**PLANNING AMENDMENTS**

**TWICKENHAM STADIUM  
 EAST STAND EXTENSION**

**SOUTH STAND JUNCTION  
 AXONOMETRIC**

Doc ref	Project number	Drawing number	Revision
100-KSS-DR	15735	343	P02

**1 3D VIEW**  
 AXONOMETRIC VIEW FROM SOUTH EAST SHOWING THE  
 NEW STAND EXTENSION MEETING EXISTING SOUTH STAND

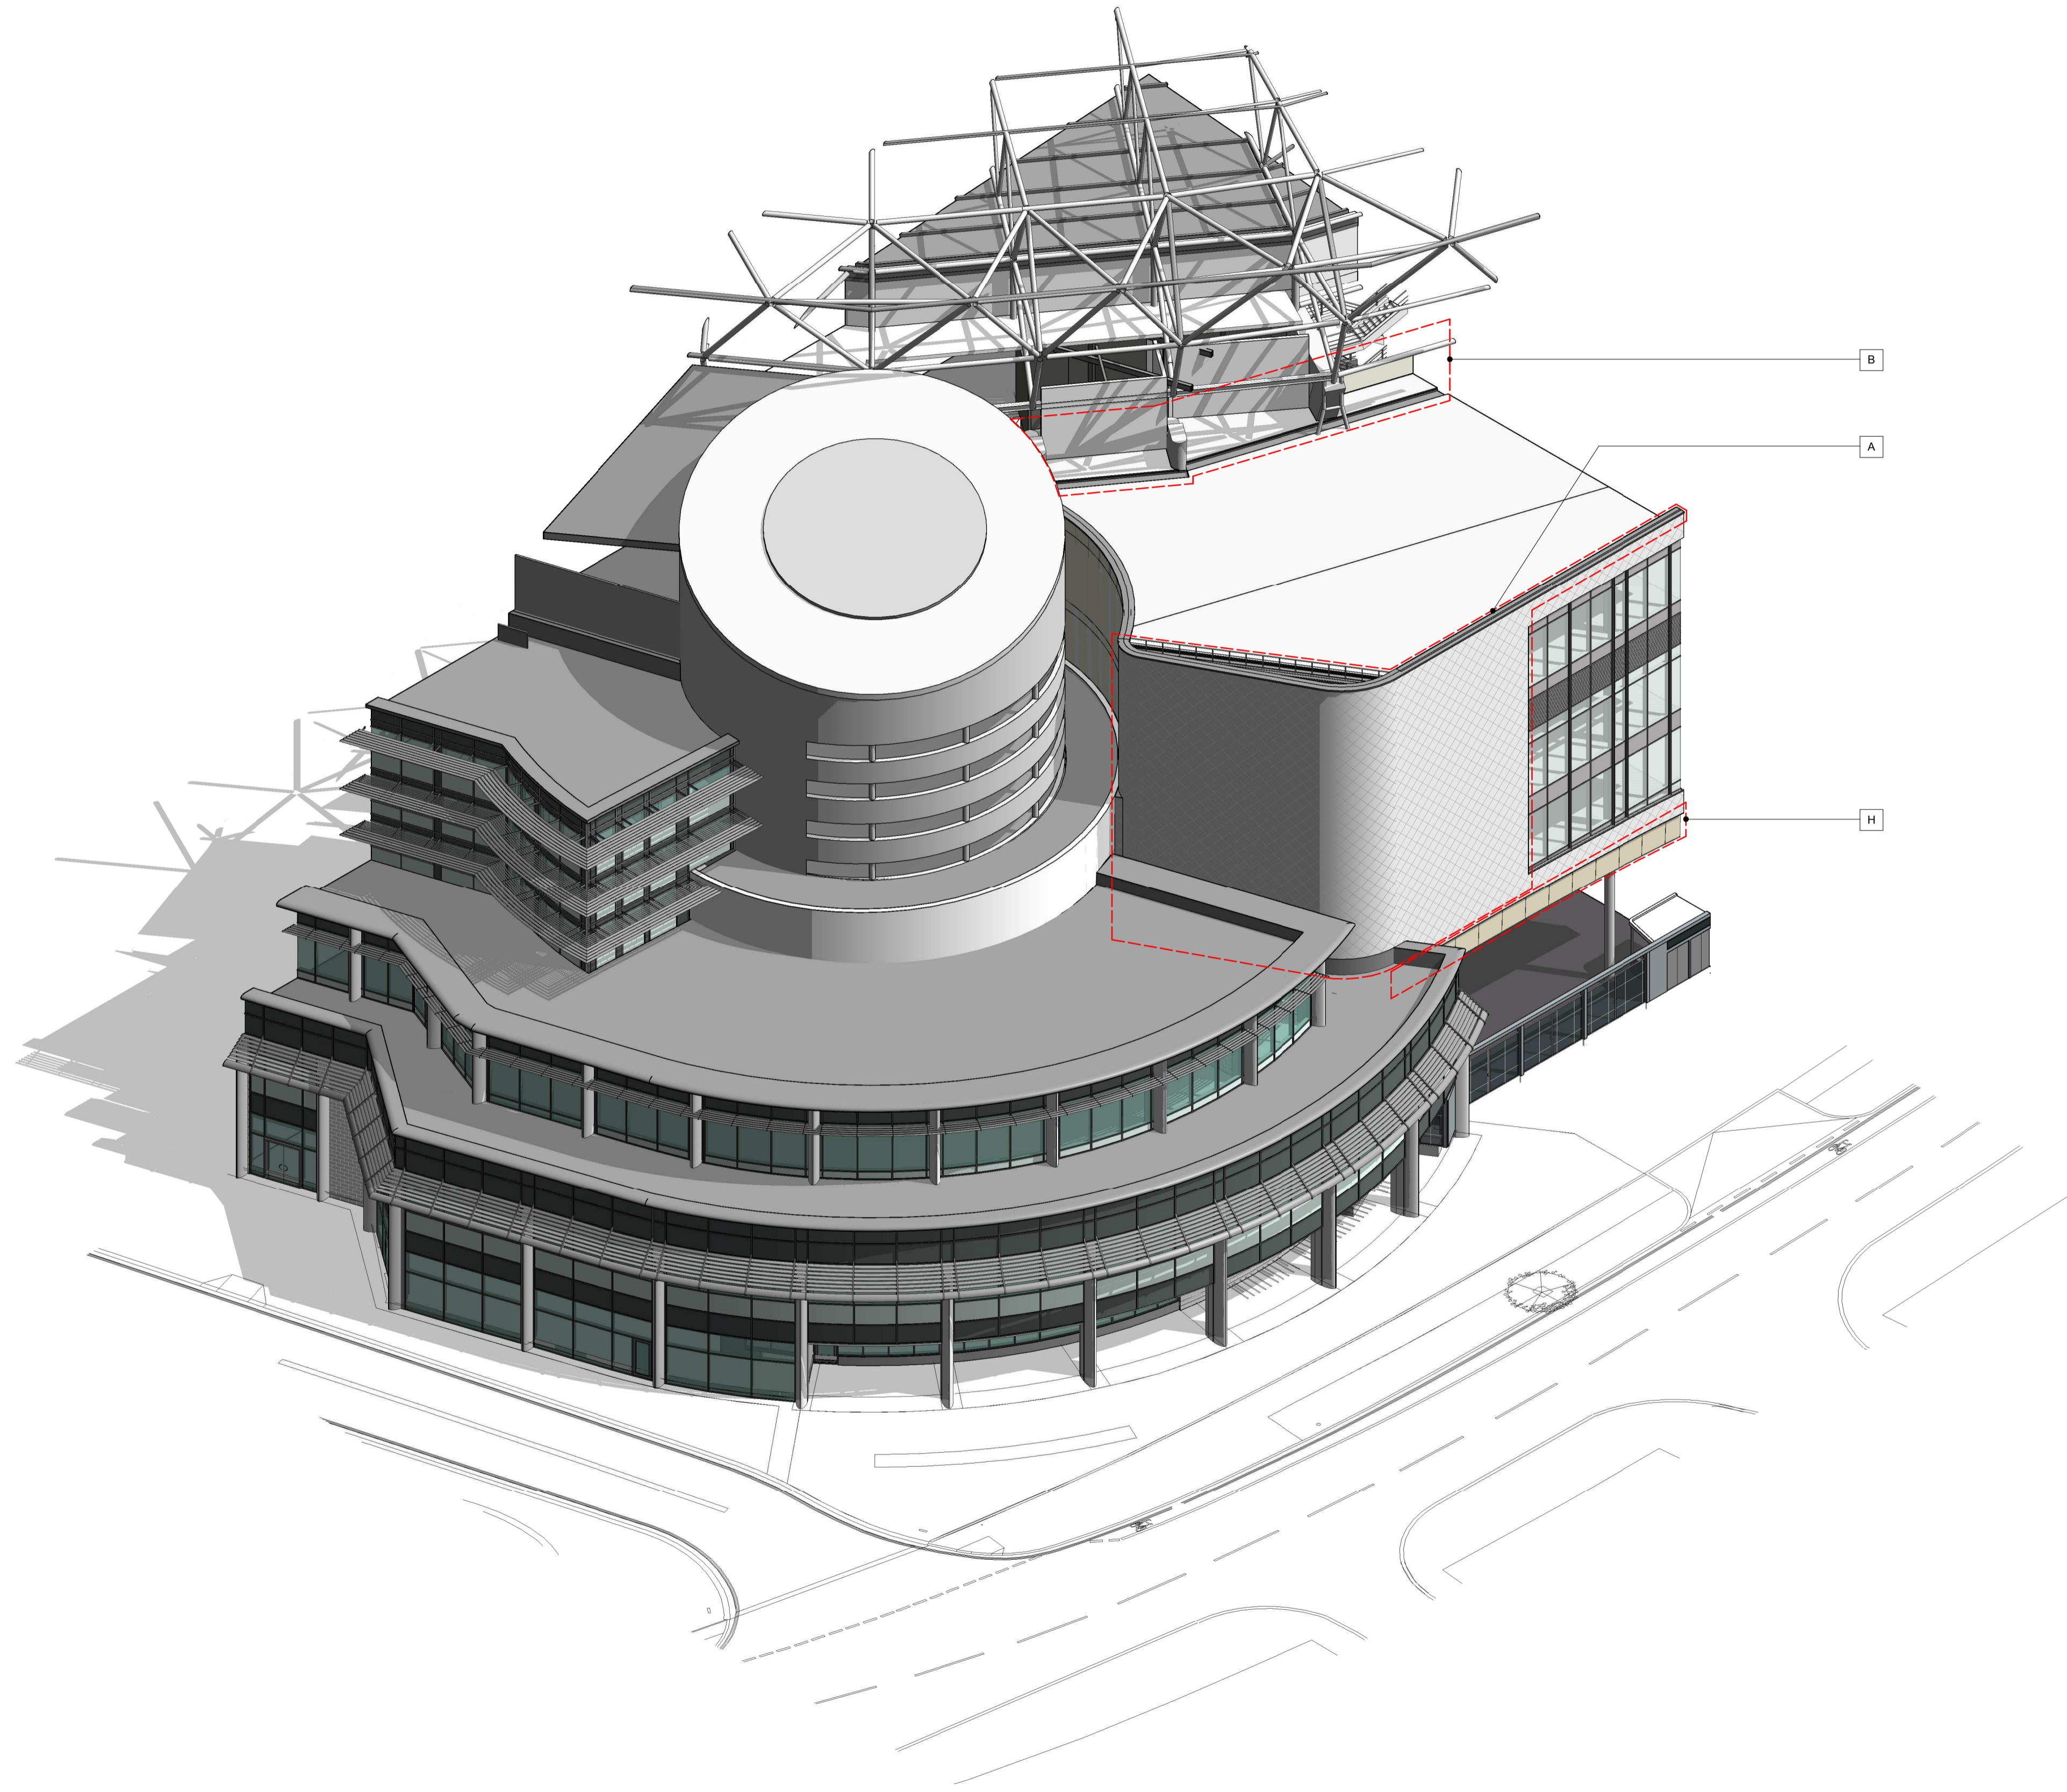
A	GENERAL AMENDMENTS TO THE SOUTH END.
A1	INCREASED SHINGLES CLADDING AREA AND CURTAIN WALL REDUCED ACCORDINGLY.
A2	REDUCED MASSING AND REVISED INTERFACE WITH THE SOUTH STAND.
B	PPC LOUVRES LOCATED TO THE BOWL SIDE HAVE BEEN OMITTED.
C	CURTAIN WALL SETTING OUT REVISED GENERALLY. SILICONE JOINTS TO TRANSOMS AND MULLION REPLACED WITH CAPPED SYSTEM. LEVEL 04 PPC LOUVRES SETTING OUT & HEIGHT REVISED. MONORAIL FOR ABSEILING REMOVED.
D	GENERAL AMENDMENTS TO THE CENTRAL ELEVATION CANOPY AT LEVEL 5A REVISED GENERALLY AND STANDING SEAM REPLACED WITH SINGLE PLY MEMBRANE. SUPPORT COLUMNS TO ROOF CANOPY REVISED. SQUARE FASCIA TO ROOF EDGE.
D1	LEVEL 5A GLAZED SCREEN EXTENDED IN HEIGHT AND PPC LOUVRES INCLUDED AT LOW LEVEL.
D2	INCREASED SHINGLES CLADDING AREA AND CURTAIN WALL AREA REDUCED ACCORDINGLY. FOUR VERTICAL FINs REMOVED.
D3	PORCELAIN PANELS WITH SLOTTED HOLES FOR VENTILATION REPLACED WITH PPC LOUVRES EXPRESSED HORIZONTAL PATTERN TO PORCELAIN PANELS OMITTED.

E	GENERAL AMENDMENTS TO THE NORTH END
E1	PORCELAIN CLADDING REPLACED WITH PPC ALUMINIUM CLADDING.
E2	GREEN WALL TO THE NORTH END EXTENDED AND PPC LOUVRES REMOVED.
E3	INCREASED SHINGLES CLADDING AREA AND CURTAIN WALL REDUCED ACCORDINGLY.
F	FENCELINE, GATE AND PERIMETER COLUMNS SETTING OUT REVISED.
F1	CANOPY TO TURNSTILES REVISED.
G	PORCELAIN PATTERN CHANGED FROM HORIZONTAL TO VERTICAL.
H	PORCELAIN PANELS TO THE SOFFIT OF THE ARCH REPLACED WITH PPC ALUMINIUM PANELS. PORCELAIN PANELS SETTING OUT REVISED.
K	ROOF TO LEVEL 5A (NORTH END) EXTENDED.
L	GLAZED SPANDREL PANELS REPLACED WITH METAL SPANDREL PANEL. PORCELAIN PANELS REPLACED WITH PPC ALUMINIUM CLADDING.
L1	PPC LOUVRES INCLUDED FOR MECHANICAL VENTILATION.
